# PUBLICATION INDEX

### SGS 2-33

K & L SOARING, LLC  
5996 STATE ROUTE 224  
CAYUTA, NY 14824

BULLETIN NO. SA-001.6\*

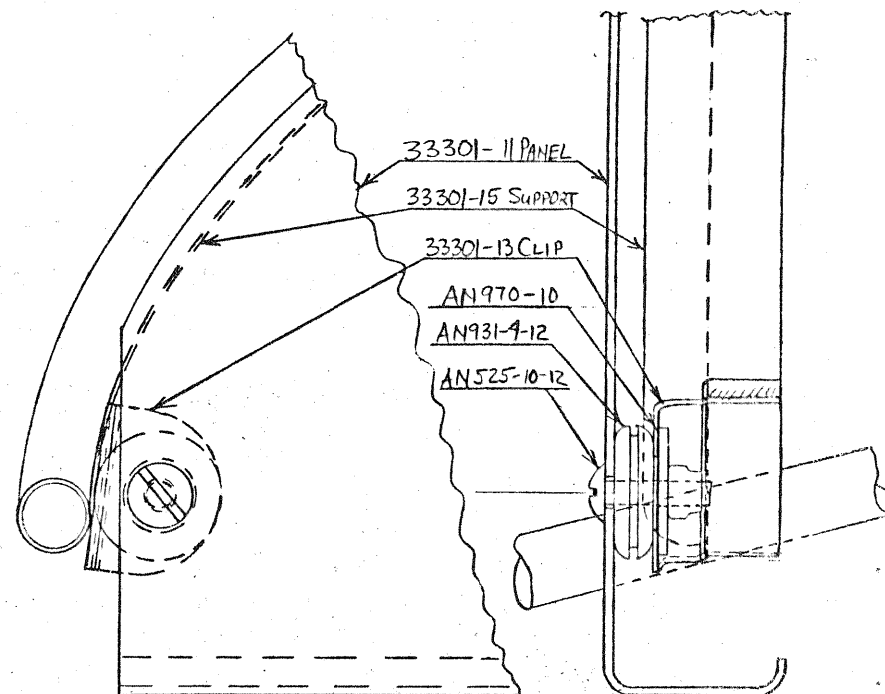
A report from the field indicates that pulling aft on the lower edge of an instrument panel during flight has resulted in an undesired release of the tow rope. V-22 "Vibrex" fasteners, used to install the 33301-1 instrument panel assembly, have a limited tensile load capacity. If the panel is pulled aft firmly, the two lower V-22 fasteners can be disengaged and the panel can force the release knob aft actuating the tow release hook.

- 1) Remove the two lower V-22 fasteners used to install the instrument panel.
- 2) Install AN522-10 screw AN931-4-12 rubber grommet, AN970-3 wood washer per the sketch on sheet 2.

## SGS 2-33 WING STRUT ATTACH OPTIONS

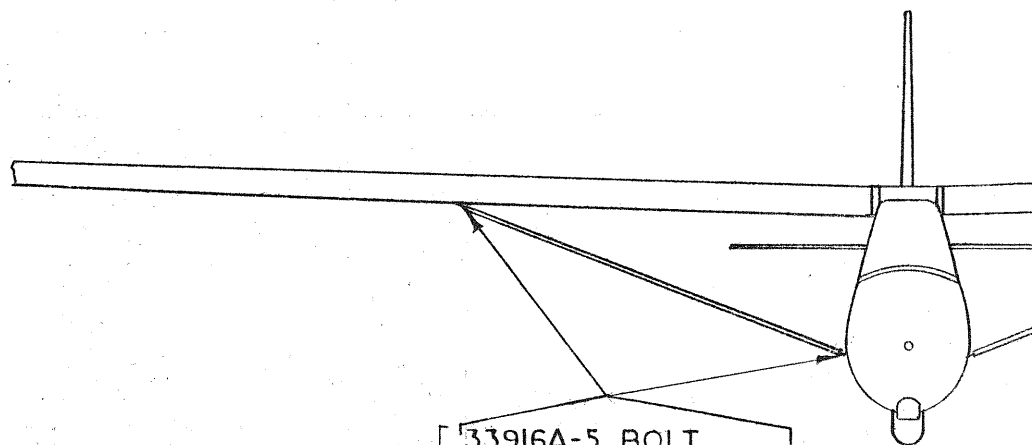
The options listed on the sketch may be used in either of the two strut locations indicated, in any combination.

- 4 — 33916A-5 BOLT  
LSP-I SAFETY PIN
- 3 — 33916A-5 BOLT  
AN310-7 NUT  
AN960-716 WASHER  
AN380-3-5 COTTER PIN
- 2 — 33916A-5 BOLT  
AN310-7 NUT  
AN960-716 WASHER  
LSP-I SAFETY PIN
- 1 — 33428B-1 BOLT  
33428B-3 COLLAR  
AN310-5 NUT  
LSP-I SAFETY PIN

Figure 1 - Tube Dimension and Minimum Wall Thickness

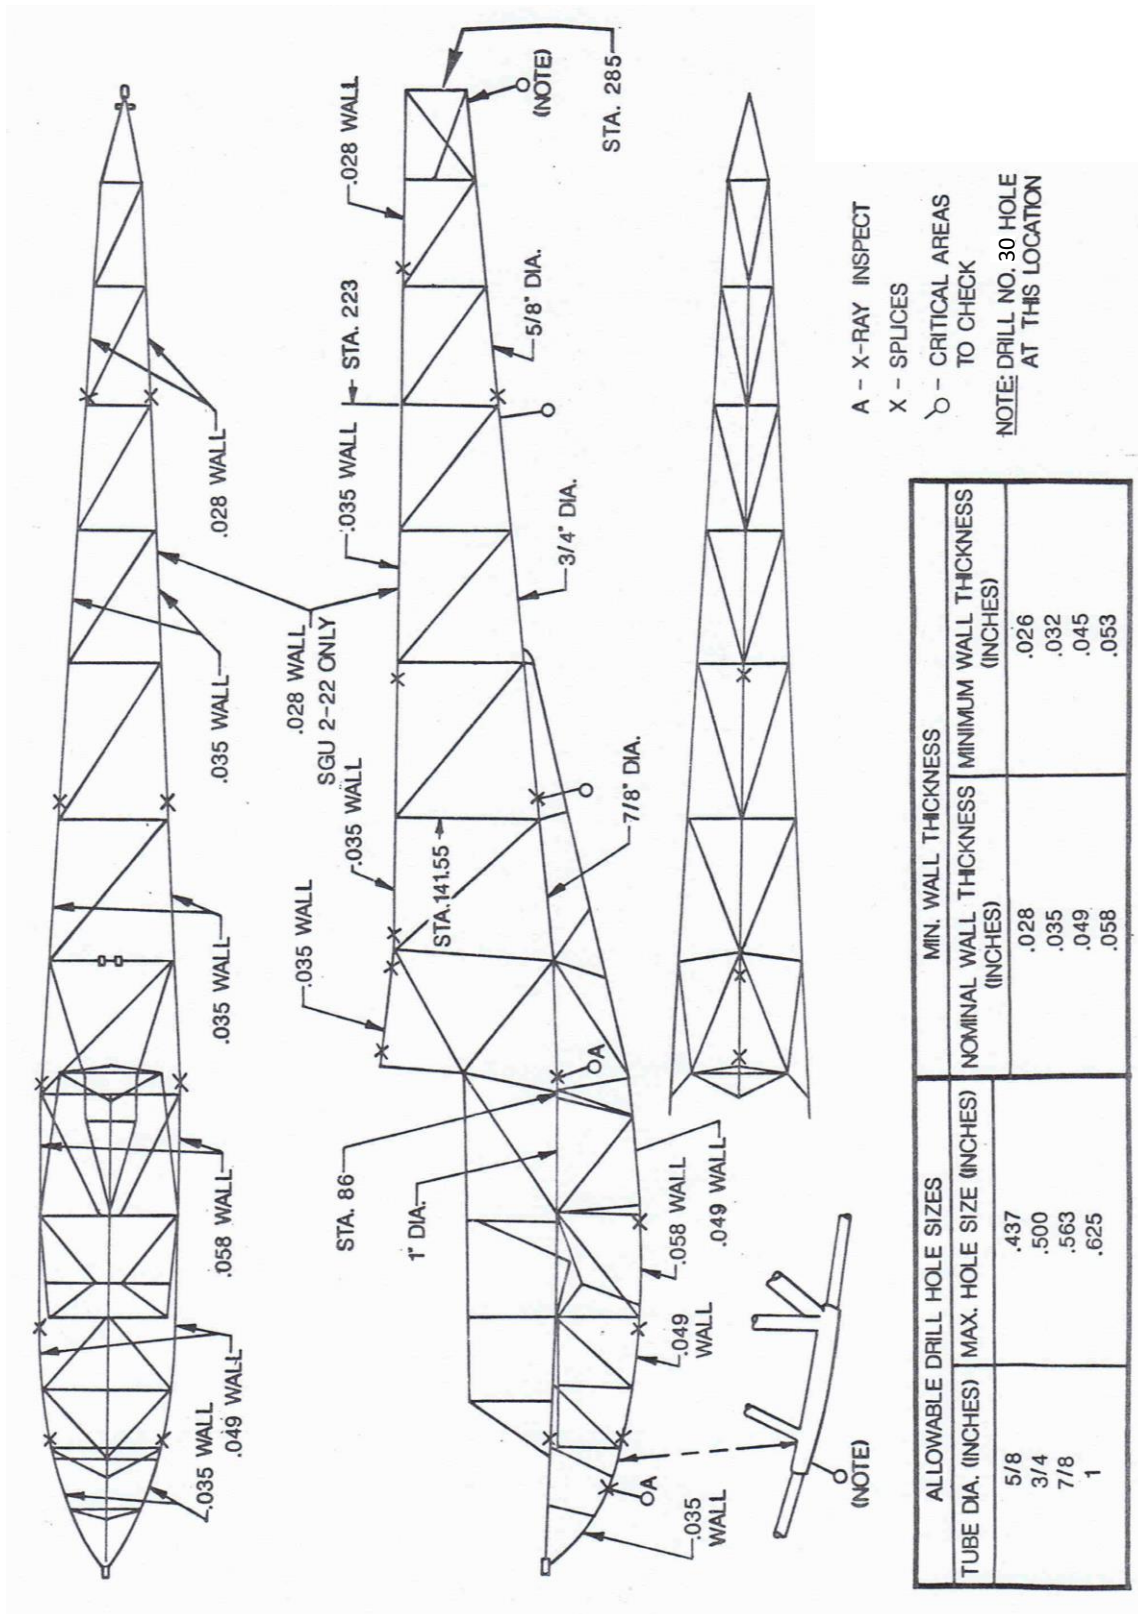
As an alternate to x-raying tubes for internal corrosion in next step, holes may be drilled at splices (areas marked A on Figure 1) to visually inspect the ID of the tubes. The holes should be drilled about 45 degrees in the lower outboard quarter of the tube just ahead of the splices. In the tail wheel area, enlarge number 30 holes to 7/16 inch maximum. (Refer to Figure 1 for other allowable hole sizes.) If corrosion exists, measure the wall thickness as shown in Figure 2. Tubes which have a wall thickness which is less than the limit specified in Figure 1, must be replaced.

- C. If water drains from holes, x-ray inspect splices of longeron tubes that are marked A on Figure 1.
- D. If any corrosion is evident, proceed as follows:
- a. Drill holes at suspect locations. (Refer to Figure 1 for maximum allowable hole size)
  - b. Measure the wall thickness as shown in Figure 2.
  - c. If wall thickness is less than the required limit (specified in Figure 1), repair or replace the tube in accordance with AC 43.13

- E. Visually inspect longeron tubes for external corrosion from inside the aircraft.
- F. If external corrosion is evident, drill holes and measure wall thickness in accordance with steps D (a) and D (b) above. If wall thickness is less than required limit (specified on Figure 1), repair or replace tubes in accordance with AC 43.13.
- G. With a dull ice pick, perform a prod test at one inch intervals along entire length of the lower surface of the longerons from station 141.55 aft to station 285.00. If ice pick penetrates tube, drill holes and measure wall thickness as specified by steps D (a) and D (b) above. If wall thickness is less than the required limit (specified on Figure 1), repair or replace tubes in accordance with AC 43.13.
